RECEIPT DATE: 1-28-20 **ONSITE SEWAGE DISPOSAL SYSTEM** P 507292

PROPERTY ADDRESS: 3213 ROSWAY COURT, GLENELG, MD 21737

Owner:	Matthew and Tricia Dunlop 3213 Rosway Court Glenelg, MD 21737		
Title:	Revised Percolation Certification Plan for 3213 Rosway Court		
Subdivision:	Roscommon Estates Lot 16		
Drawing Prepared By:	 RHINE LANDSCAPING, LLC 17000 Old Baltimore Road, Suite 100 Glenelg, MD 21737 410-442-2445 www.rhinelandscaping.com		
Tax Map:	22	Plat Ref:	8263
Parcel:	549	Election Dist.:	3rd
		Date:	1/2/20
		Sheet:	1 of 1

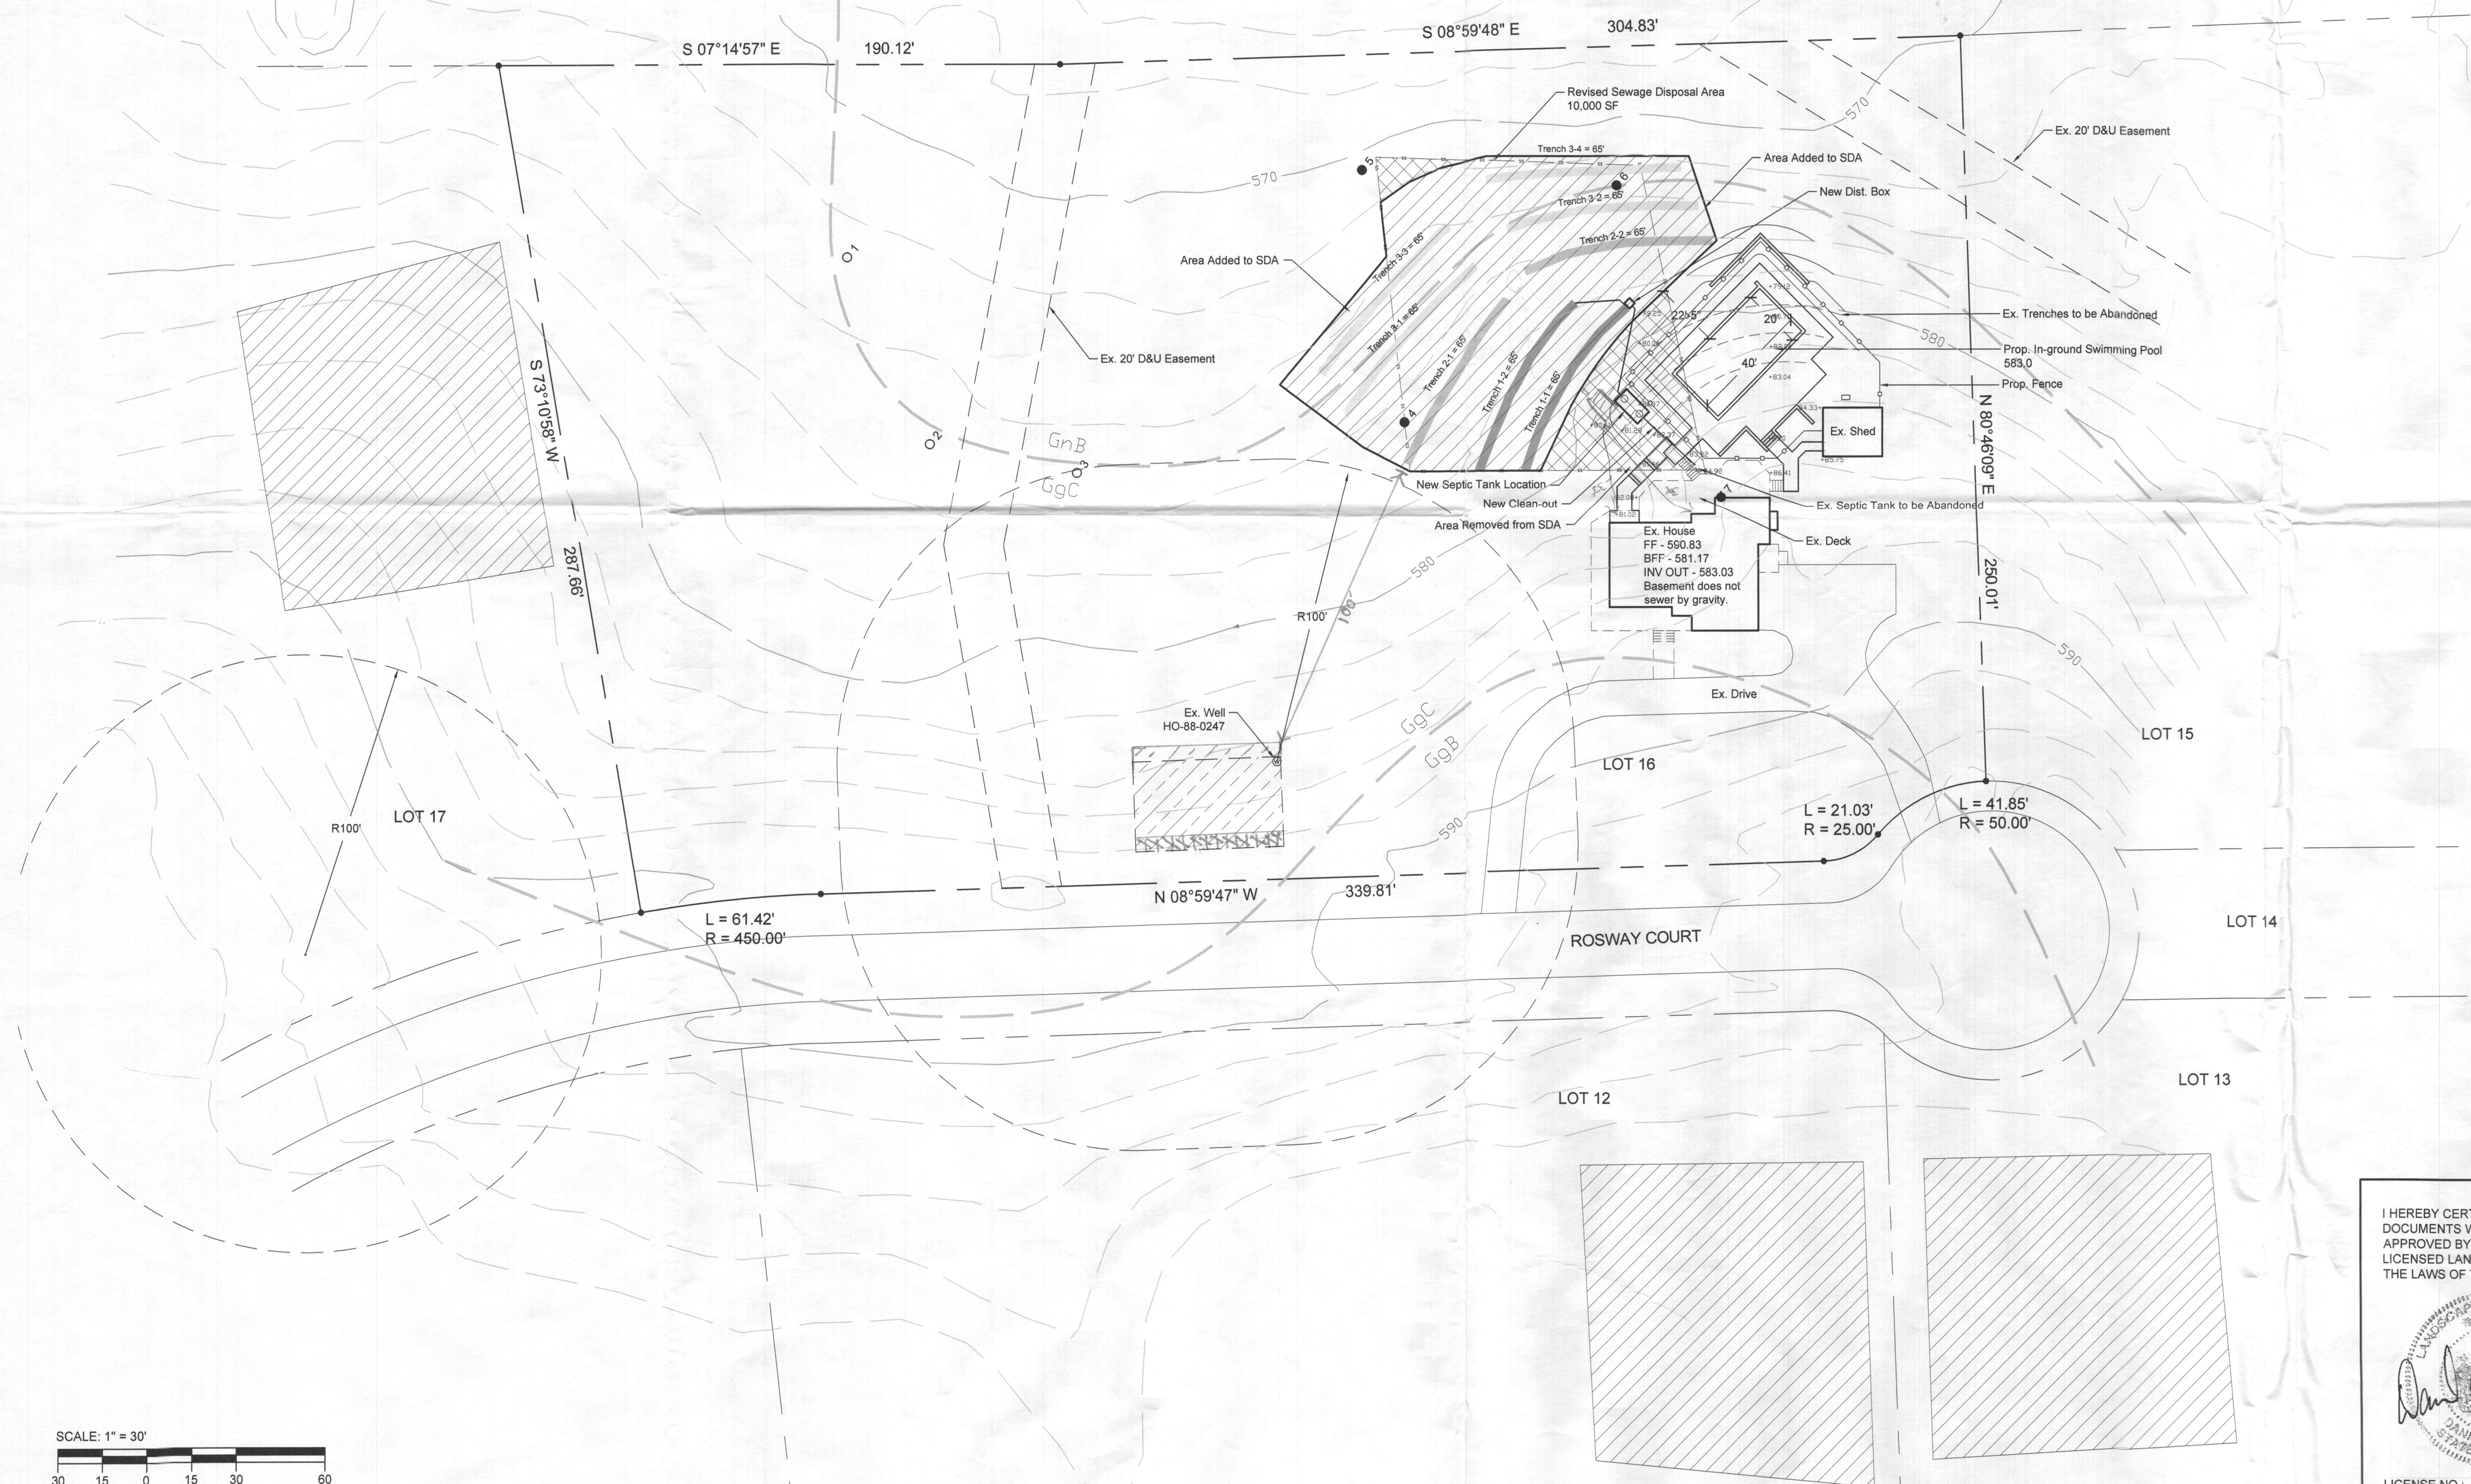
02/03/2020 MOVED TANK TO 25' OFF POOL WATERS EDGE. SPLIT TRENCHES INTO 4 X 33' TRENCHES.

CONFIRM WITH MANUFACTURER @ 2/4/2020 Sewer line connected into existing sewer line. Three trenches constructed and d-box set. Reinspect d-box for elbow joint going into box, needs to be redone (second left trench when facing away from tank). (SD) 2/5/2020 Last trench constructed. D-box leveled. Elbow into d-box replaced. (SD)

02/03/2020
 Make Tank 25' FROM POOL
 SPLIT TRENCHES INTO 4x33s
 DATELESS TANK SET
 RECOVER
